**SUBJECT:** NuScale Power, LLC Response to NRC Request for Additional Information No. 386 (eRAI No. 9316) on the NuScale Design Certification Application

## **Response to Request for Additional Information Docket No. 52-048**

**eRAI No.:** 9316

**NRC Question No.:** 03.09.02-54

Figure 2-4 Steam piping downstream of steam nozzles

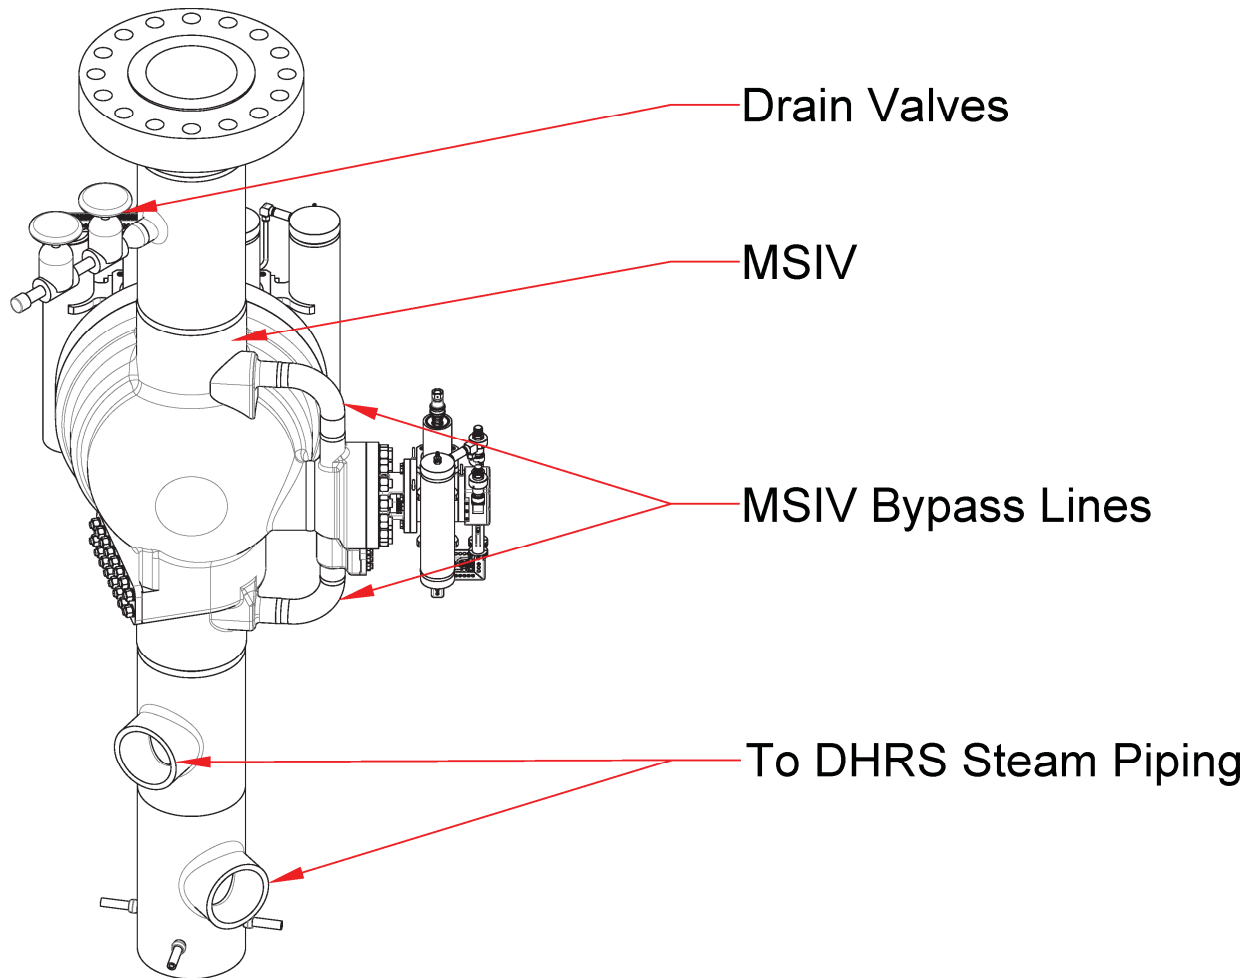
Provide the detailed information on acoustic resonance (AR) assessments to the CVAP report as originally requested in RAI 8884, Question 03.09.02-7, particularly on the decay heat removal system (DHRS) standby modes. Given that strong acoustic resonances excited by second order shear layer flow instabilities have been observed in the main steam lines of boiler water reactors (BWRs) it has been common practice for licensees requesting Extended Power Uprates (EPU) or those proposing new plant designs to confirm that first and second order shear layer instabilities do not lock-on to sidebranch acoustic modes and damage valves or generate acoustic loads which could damage other components including reactor internals. Other evidence of the ability of 2nd order instabilities to excite acoustic resonances are available in Ziada and Lafon, "Flow-excited acoustic resonance excitation mechanism, design guidelines, and counter-measures," Applied Mechanics Reviews, Vol. 66, Jan 2014. Expand the NuScale AR assessments, particularly in the DHRS, to include second order instabilities. Also, given the small margin against AR at the primary shear layer modes, explain in detail how AR will be assessed and, if necessary, mitigated during initial startup or other testing. Without the information, the staff cannot reach a reasonable assurance finding on the structural integrity of the reactor internals components to withstand the adverse effects of vibration.

#### 2.3.1.1 Steam Piping, Plenum Exit Nozzle, ~~and Main Steam Isolation Valve, MSIV~~ Upstream and Downstream Bypass Lines, CNTS MS Drain Valve Branch

The SGS piping includes the steam piping inside containment (see Figure 2-4). The SGS steam lines initiate at the steam supply nozzle safe ends on the steam plenums and terminate inside the CNV at the CNV penetration nozzle safe ends. Outside the CNV, the steam lines are termed CNTS steam piping through the MSIV to the NPM disconnect flange. The CNTS steam lines have three regions of side branches that are closed during normal operation: the tees to the DHRS steam lines, connections upstream and downstream of the MSIV body to the bypass MSIV, and branch lines to the CNTS MS drain valves. ~~are connected to the DHRS.~~

These components meet the screening criteria for AR. Vortices can potentially form off the leading edges of transitions within these components. Similar shedding could potentially occur due to shedding off the main steam valve bodies. When shedding frequencies become close or equal to the acoustic frequencies of the downstream piping and valve or nozzle bodies, AR can occur. No other FIV phenomena are credible for these regions.
